Watts Bar Nuclear Plant, Unit 1  
Facility Operating License Nos. NFP-90  
NRC Docket No. 50-390

Subject: **Application to Revise Technical Specification 4.2.1, "Fuel Assemblies" (WBN-TS-15-03) (TAC No. MF6050) - Response to NRC Request for Additional Information - Reactor Systems Branch**

#### TVA Response to NRC Request for Additional Information

Schematic of the Pellet Leaching Test Configuration

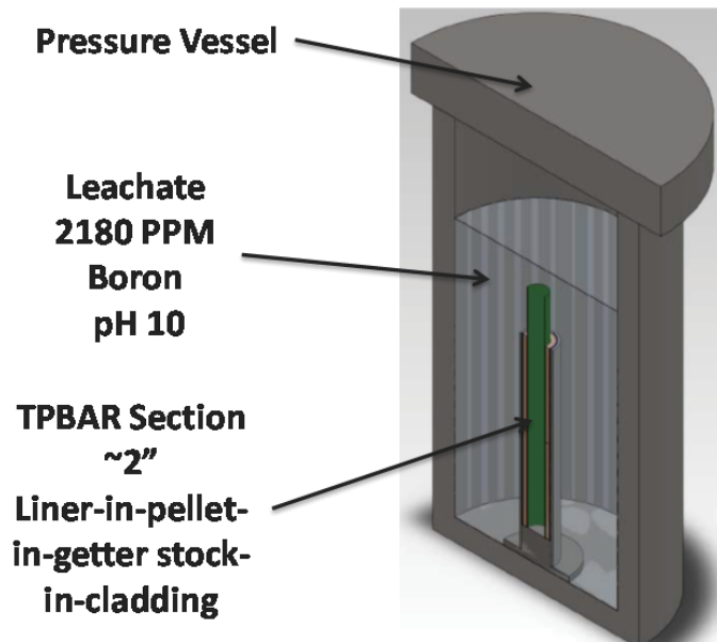
The post-Loss of Coolant Accident (LOCA) subcriticality assessment was performed using revised assumptions for leaching of lithium from the core due to TPBAR failures. A series of Pacific Northwest National Laboratory (PNNL) tests are used as justification for the new assumptions. However, little information is provided about the PNNL tests other than the experiment durations and the temperature at which the tests were conducted. Provide the following information:

- a. A description of the test conditions, including ambient fluid conditions, fluid flow, installation configuration for the TPBAR, and mechanical loads.

The tested configuration consisted of a sample TPBAR section in a pressure vessel as shown in the figure below. Each sample TPBAR section was fabricated with uncoated cladding and getter stock, production inner material, and two irradiated lithium aluminate pellets ( $\text{LiAlO}_2$ ). A buffered, pH-adjusted borated test solution (2180 ppm boron and pH of 10) was used to simulate the sump water. The test solution was periodically sampled and replaced with fresh solution.

The leach tests were performed in unstirred stainless steel pressure vessels at  $120^\circ\text{C}$  and as-generated pressures. An actual TPBAR cladding breach creates a tortuous path that does not allow for free flowing coolant interaction with the pellet material. Therefore, no continuous flow past the TPBAR sections was used in the leach testing. Leaching of  $\text{LiAlO}_2$  within a breached TPBAR occurs in stagnant conditions within the TPBAR. However, to conservatively bound the breach configuration relative to coolant interaction with the pellets, an open ended cladding section was used in the pellet leach test. The test included the mechanical loads due to temperature effects, thermal expansion and pressure. The test was conducted at bounding post-LOCA temperature and pressure conditions.
